City Campus Student Accommodation Building B

Drawing Name
HARDWORKS - GROUND FLOOR

Issued under the *Environmental Planning and Assessment Act 1979*
Approved Section 4.55 (1A) Modification Application
Approved Application No: SSD 61618229 Mod 1
Approved on: 27 February 2026
Signed: AW Sheet No: 2 of 8

Project Status
SSDA MODIFICATION

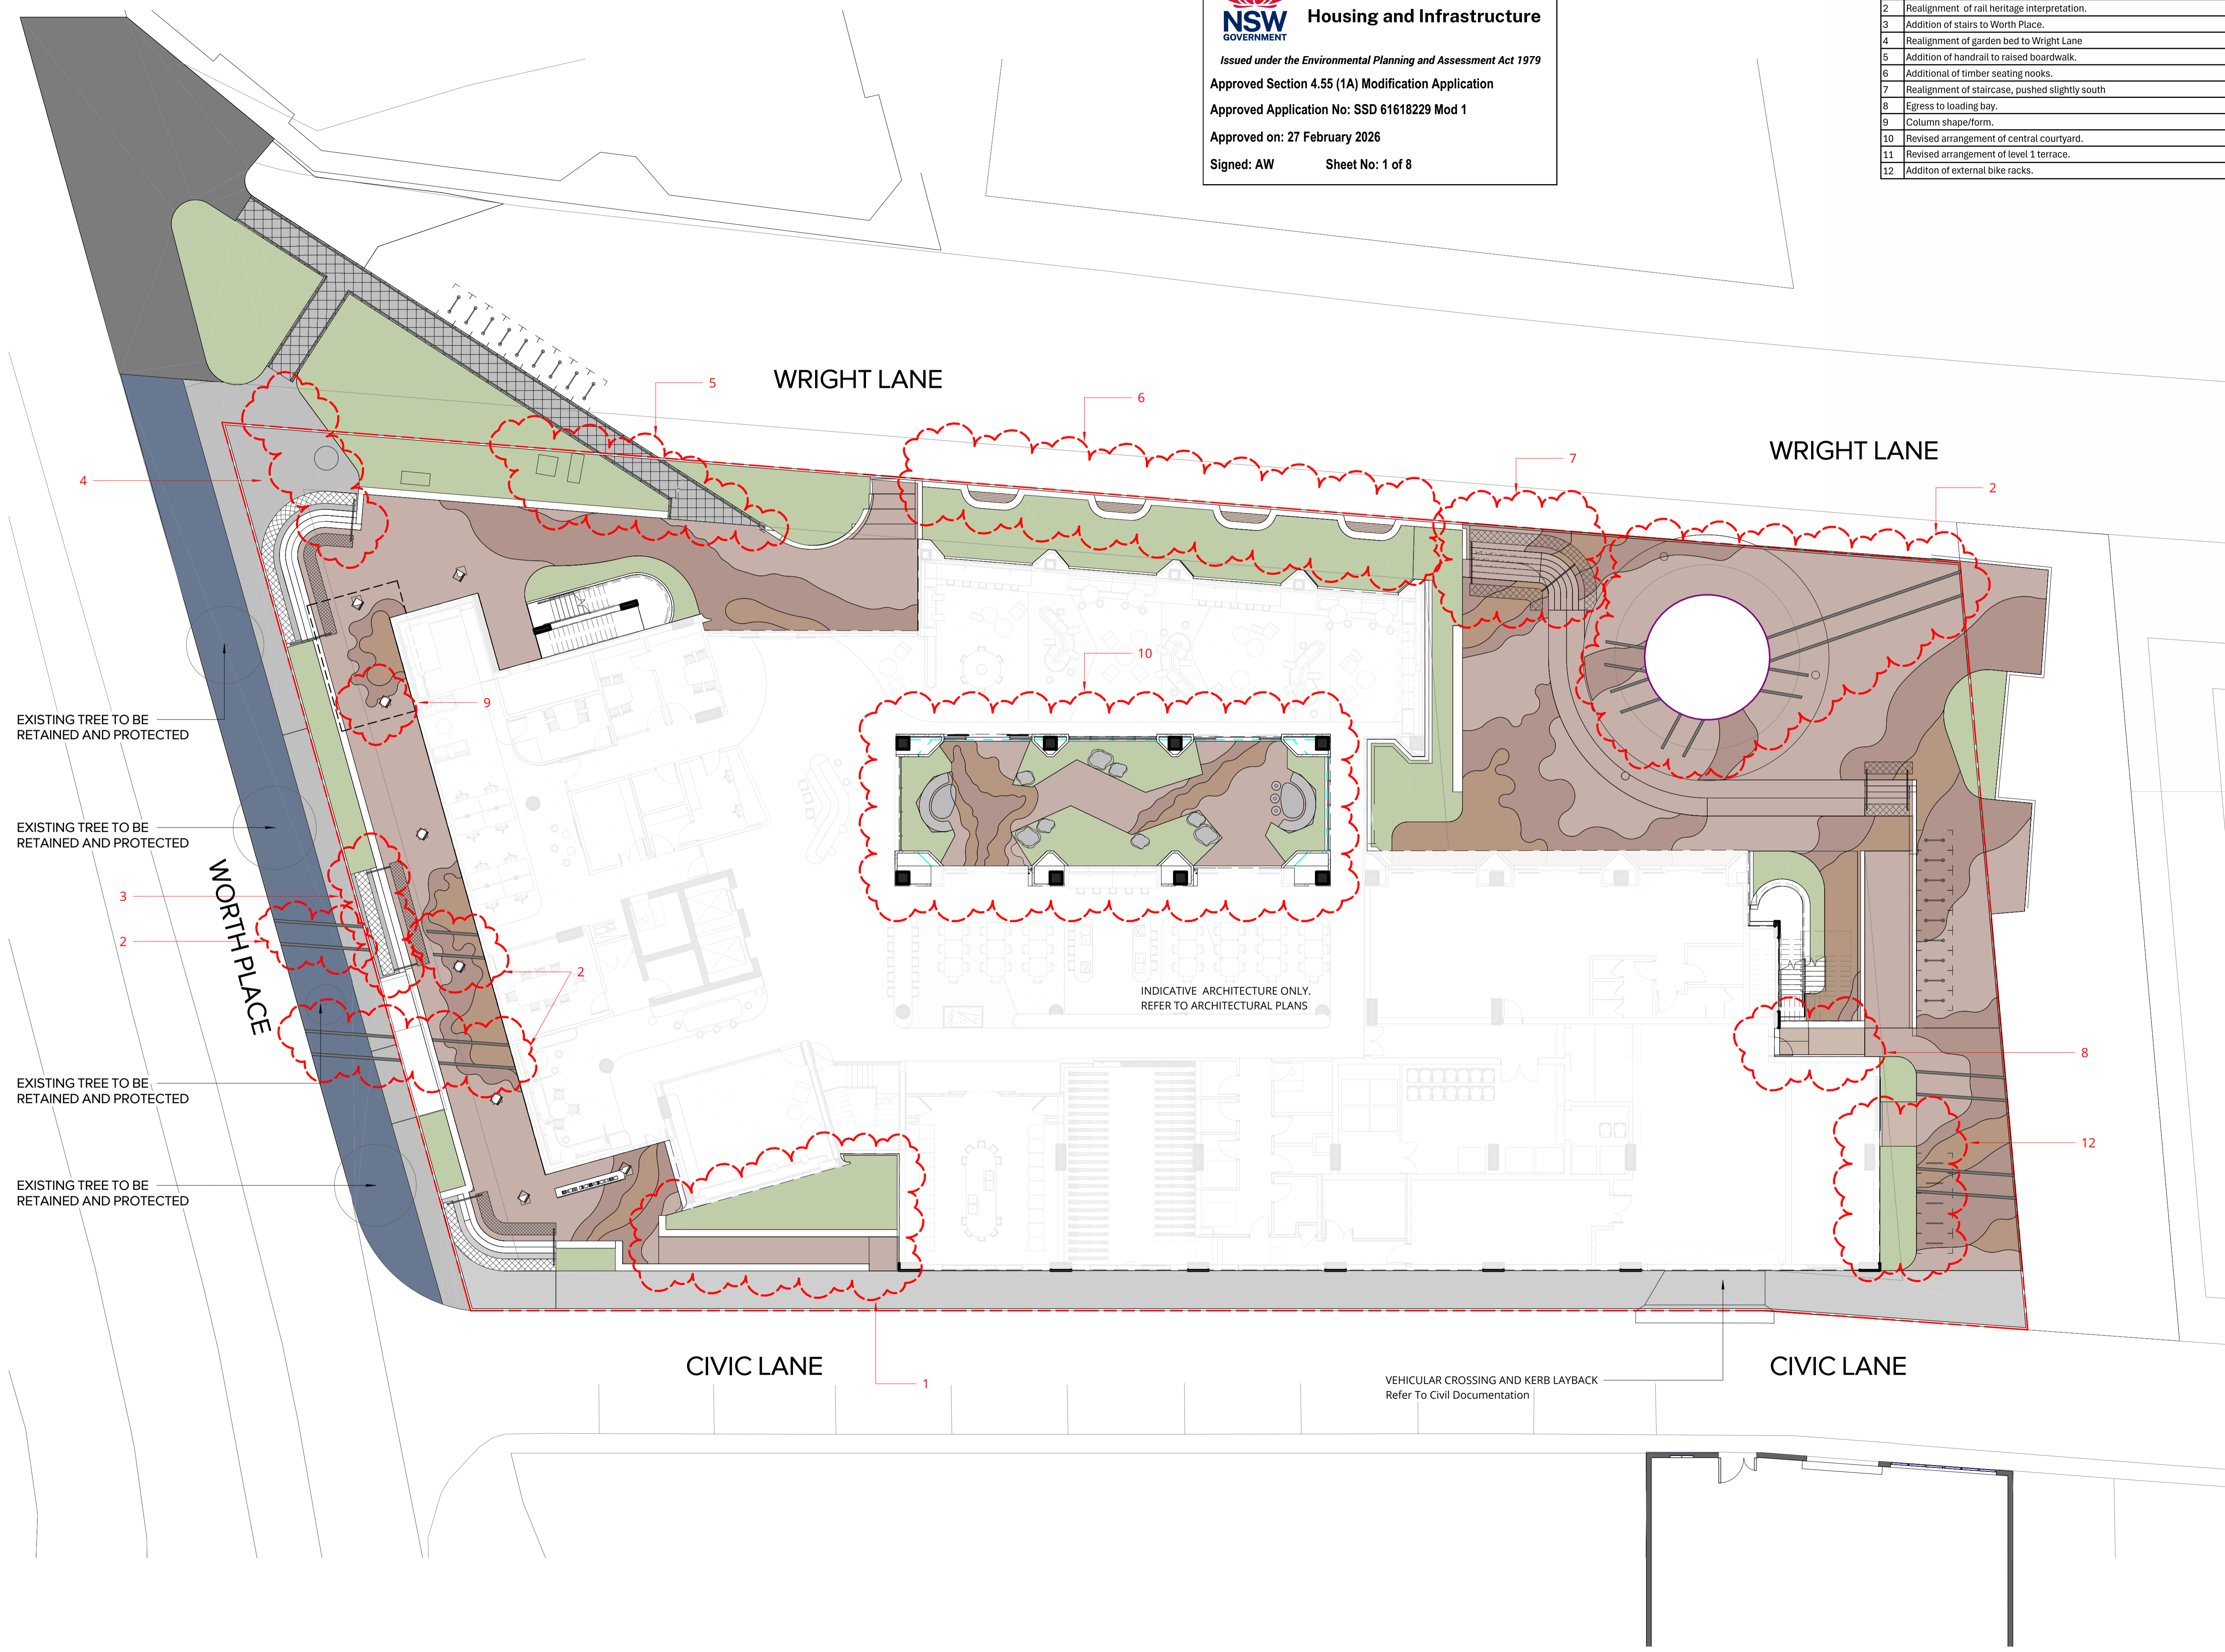
No.	Design Change
1	Removal of trees to Civic Lane garden bed.
2	Realignment of rail heritage interpretation.
3	Addition of stairs to Worth Place.
4	Realignment of garden bed to Wright Lane
5	Addition of handrail to raised boardwalk.
6	Additional of timber seating nooks.
7	Realignment of staircase, pushed slightly south
8	Egress to loading bay.
9	Column shape/form.
10	Revised arrangement of central courtyard.
11	Revised arrangement of level 1 terrace.
12	Addition of external bike racks.

Drawing No.
L-CCSA-FLR-20133
Drawing Name
HARDWORKS - LEVEL 1

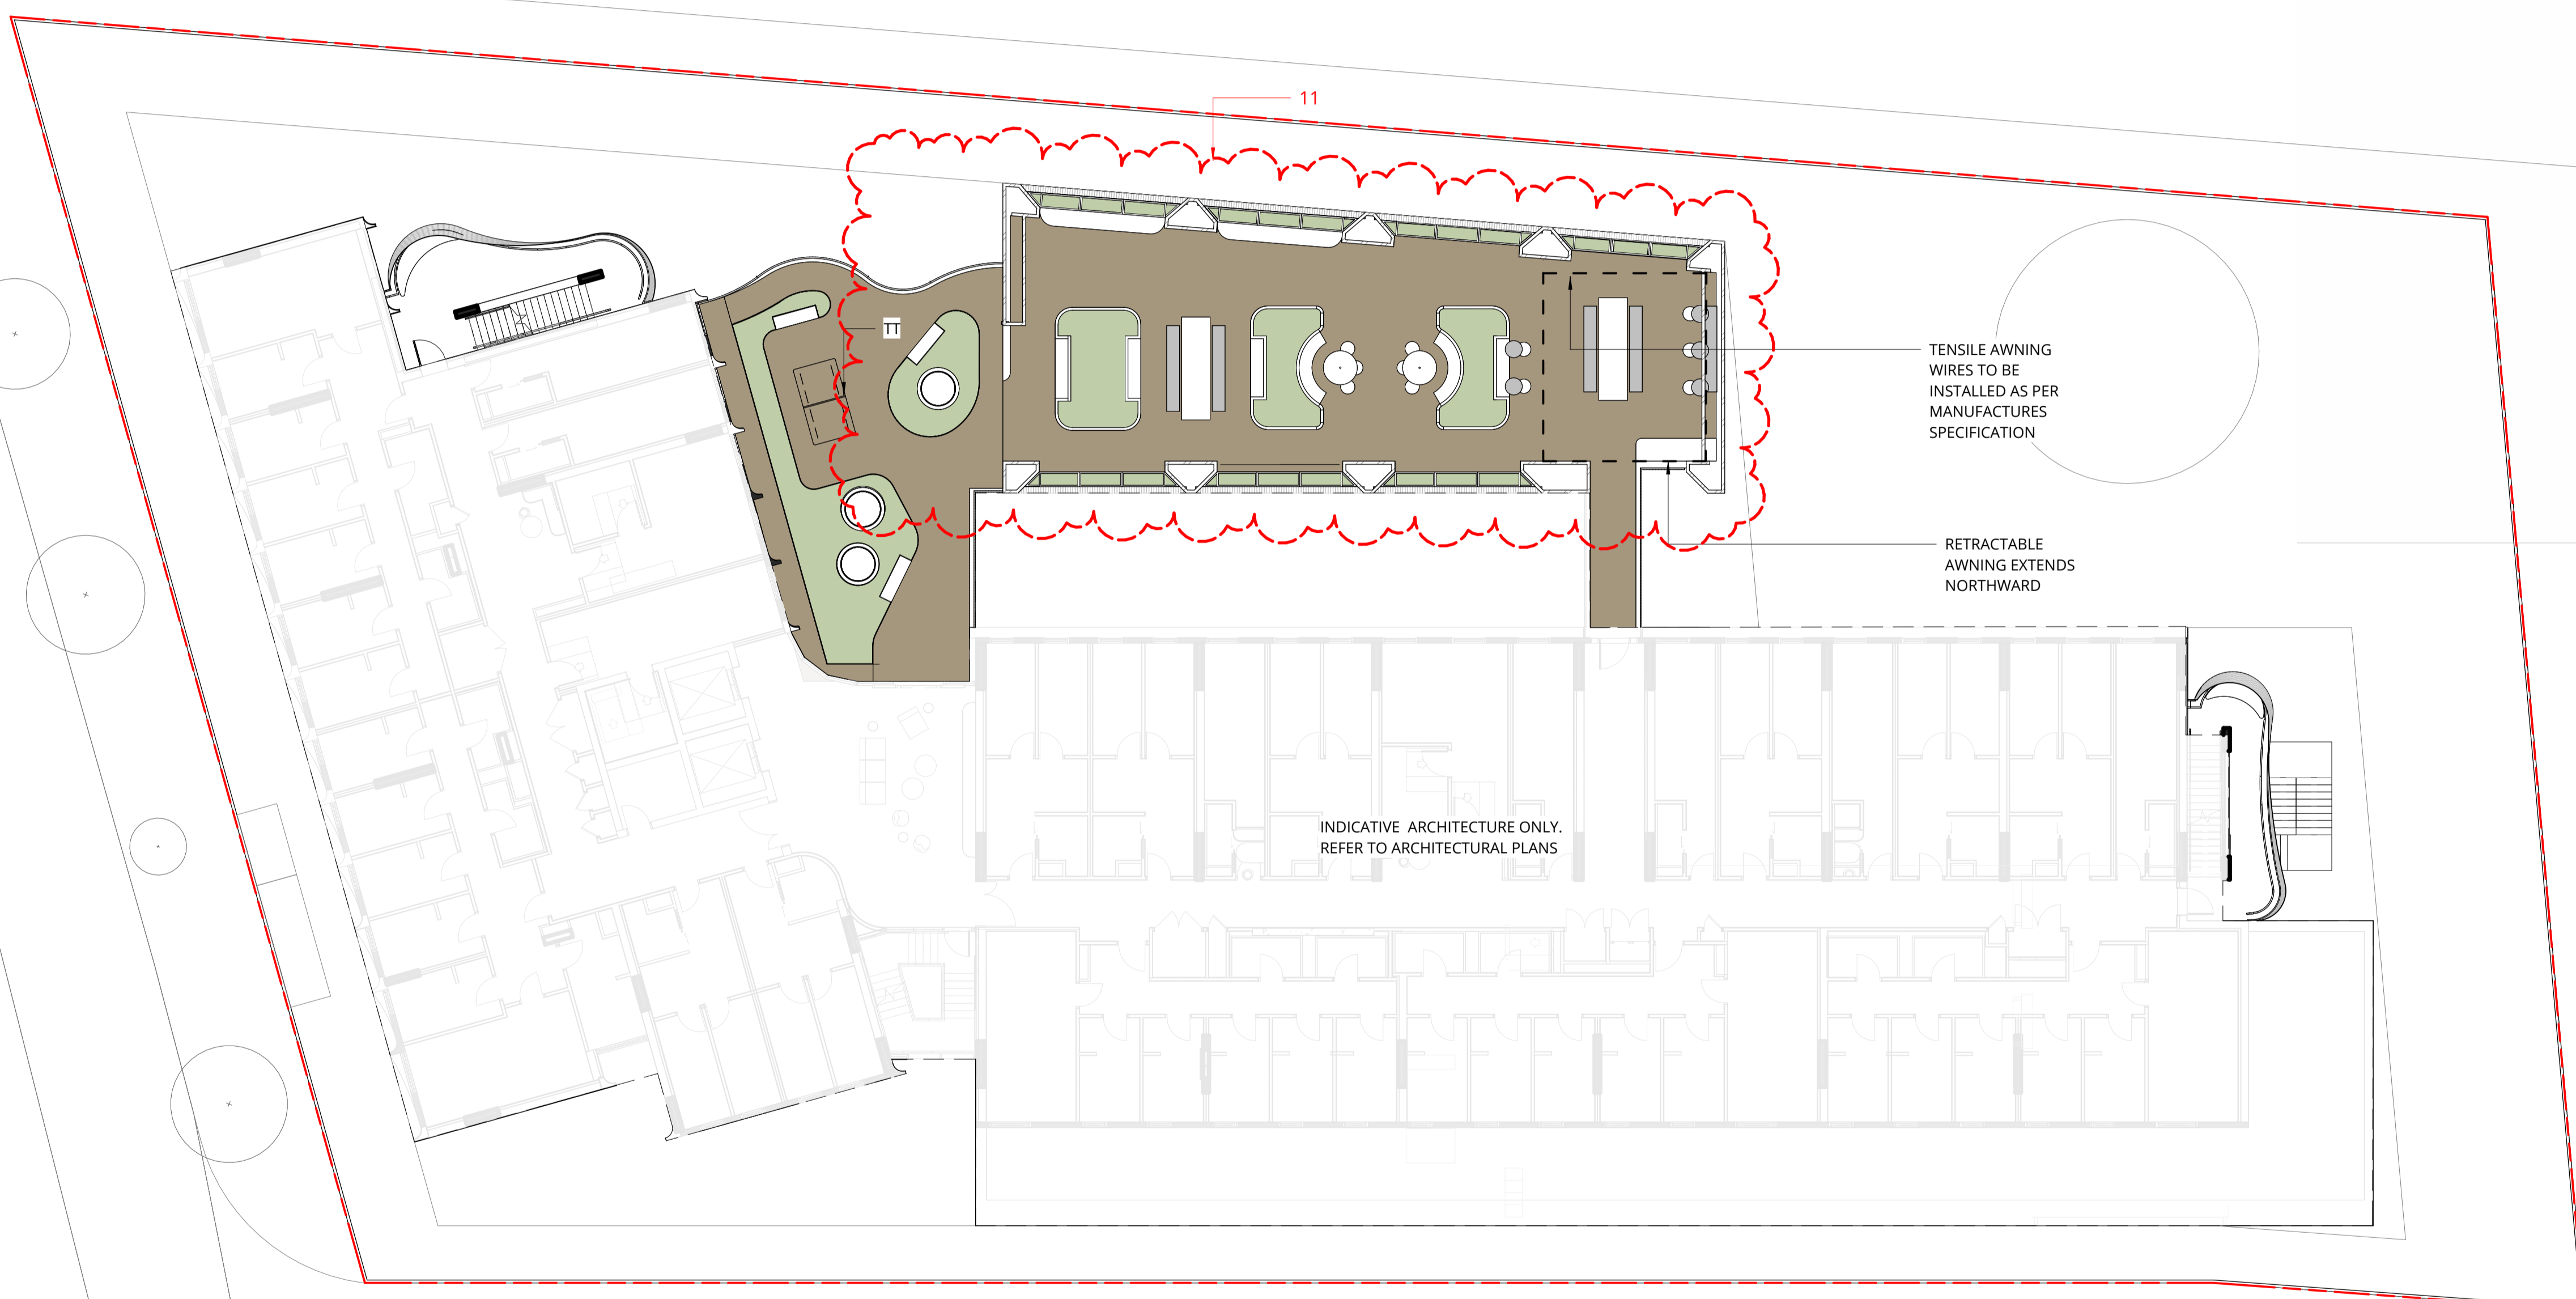
No.	Design Change
1	Removal of trees to Civic Lane garden bed.
2	Realignment of rail heritage interpretation.
3	Addition of stairs to Worth Place.
4	Realignment of garden bed to Wright Lane
5	Addition of handrail to raised boardwalk.
6	Additional of timber seating nooks.
7	Realignment of staircase, pushed slightly south
8	Egress to loading bay.
9	Column shape/form.
10	Revised arrangement of central courtyard.
11	Revised arrangement of level 1 terrace.
12	Additon of external bike racks.

Drawing Name:
SOFTWARES - GROUND
FLOOR

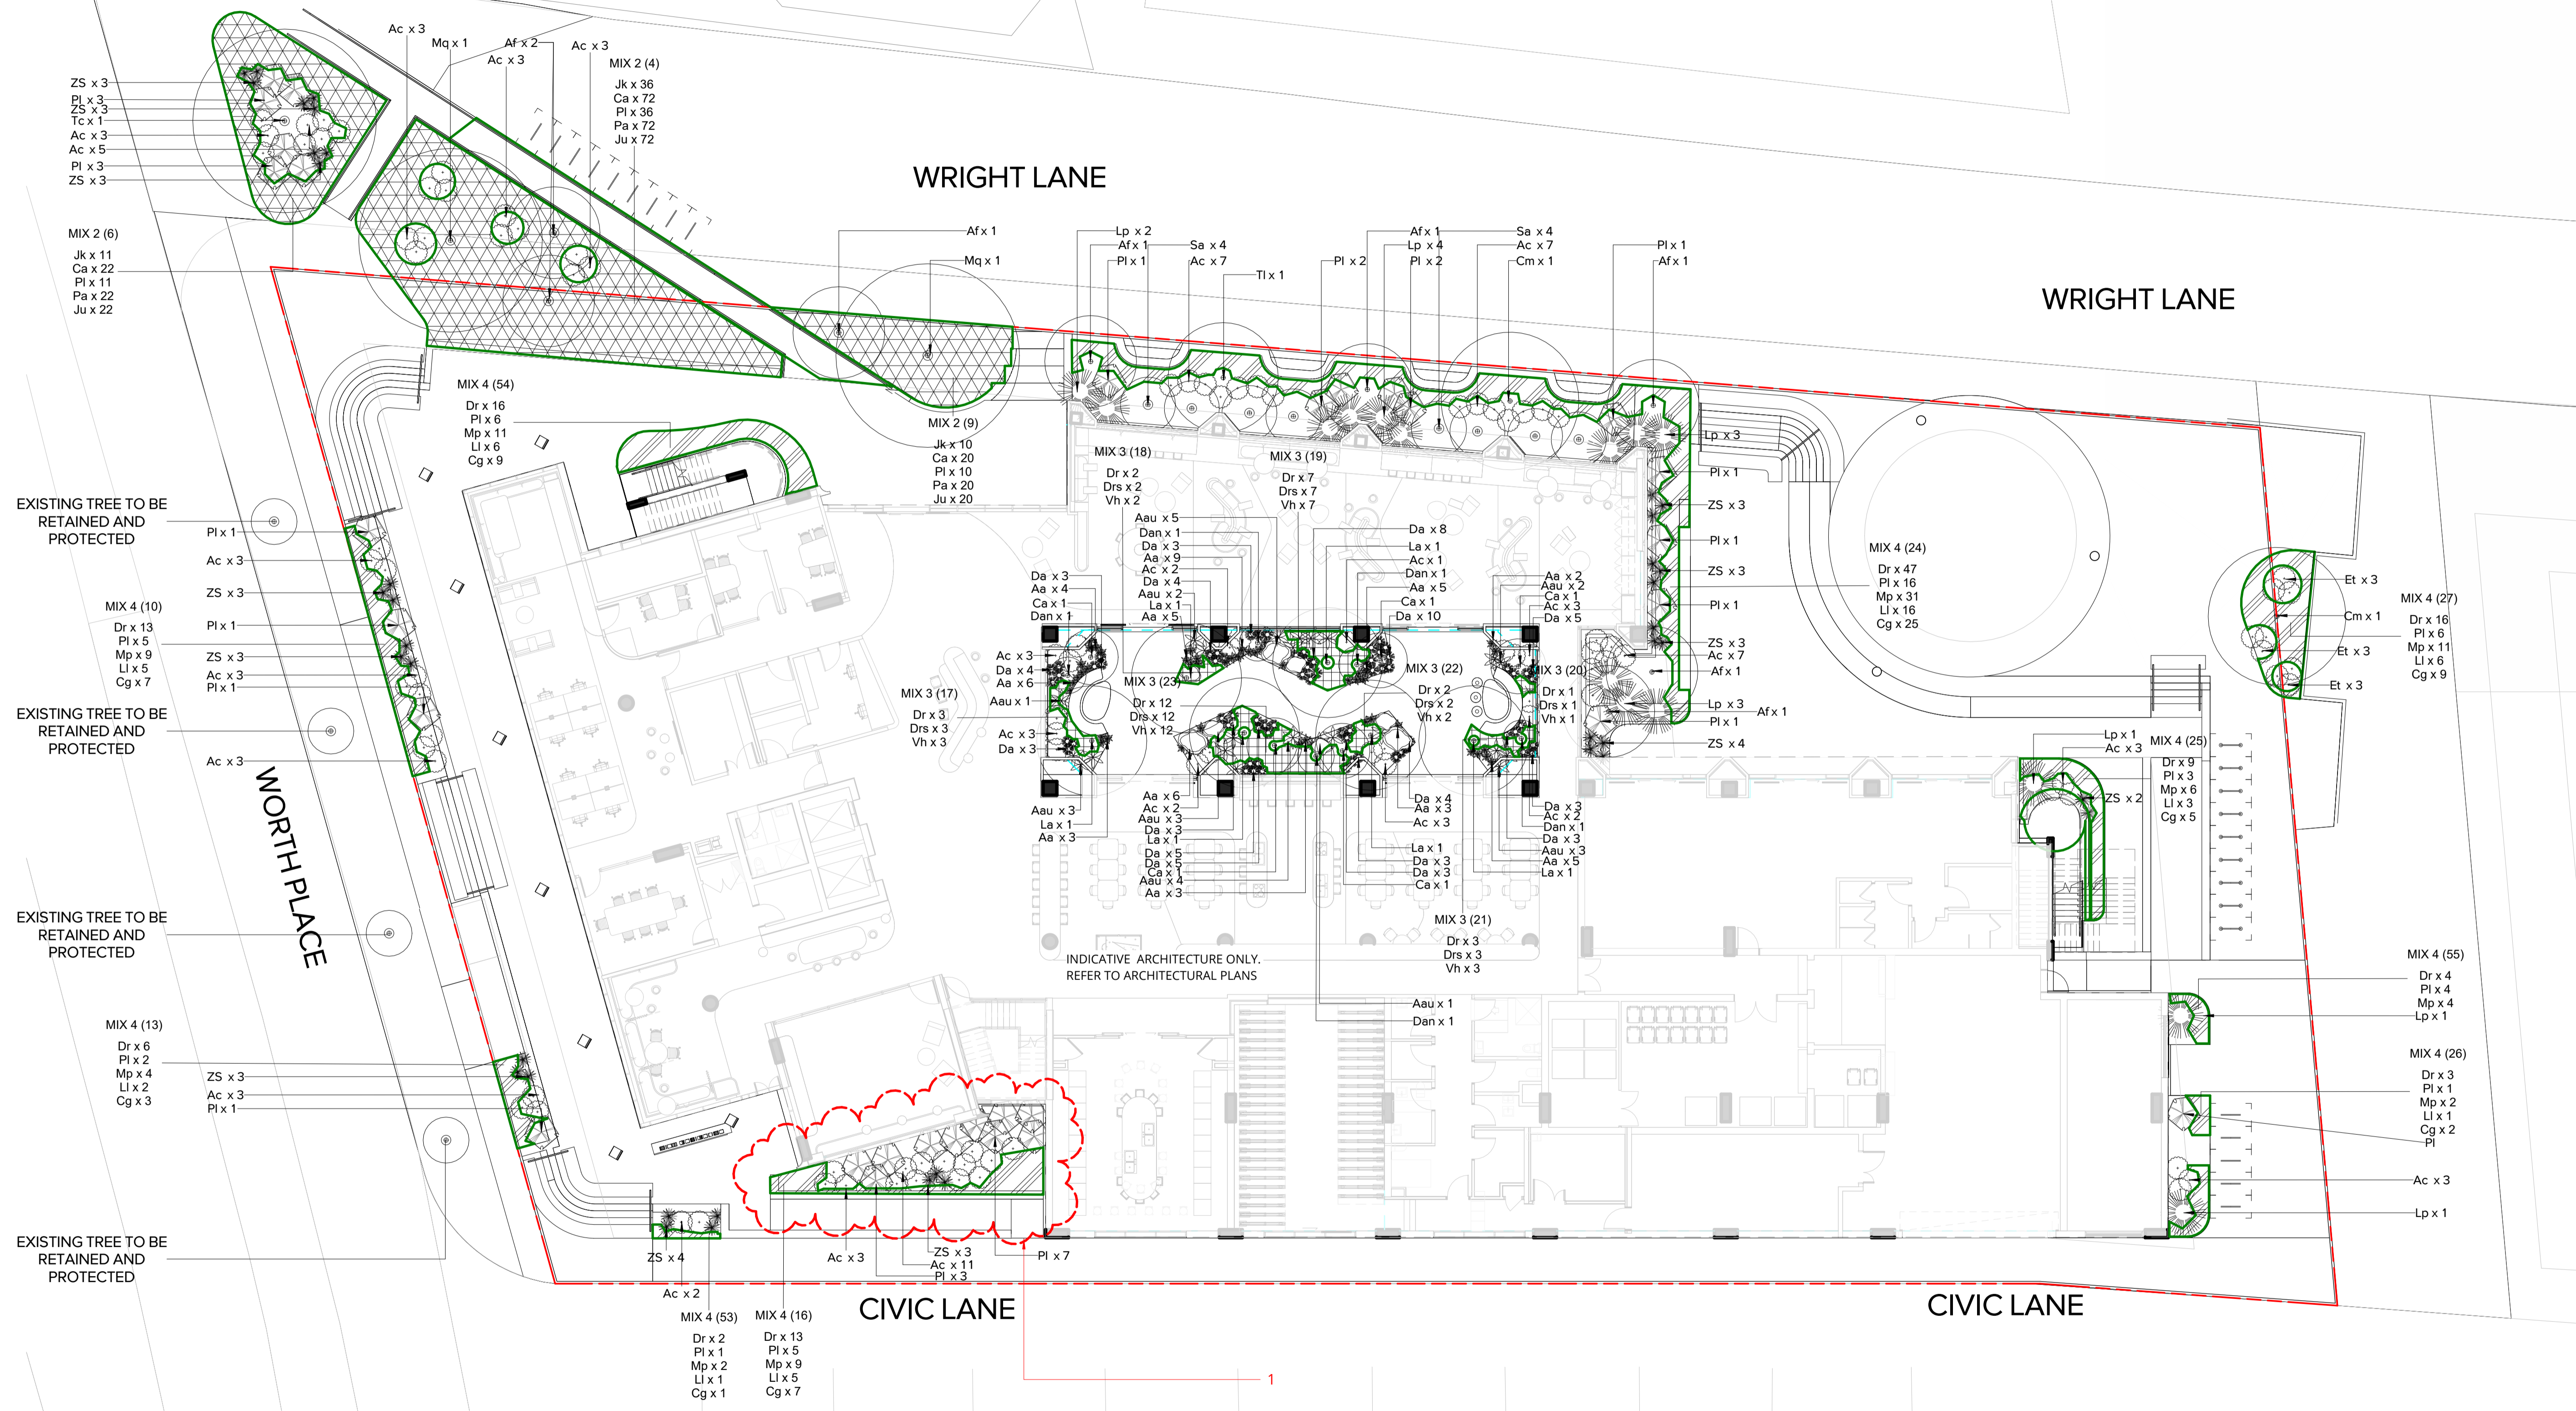
No.	Design Change
1	Removal of trees to Civic Lane garden bed.
2	Realignment of rail heritage interpretation.
3	Addition of stairs to Worth Place.
4	Realignment of garden bed to Wright Lane
5	Addition of handrail to raised boardwalk.
6	Additional of timber seating nooks.
7	Realignment of staircase, pushed slightly south
8	Egress to loading bay.
9	Column shape/form.
10	Revised arrangement of central courtyard.
11	Revised arrangement of level 1 terrace.
12	Addition of external bike racks.
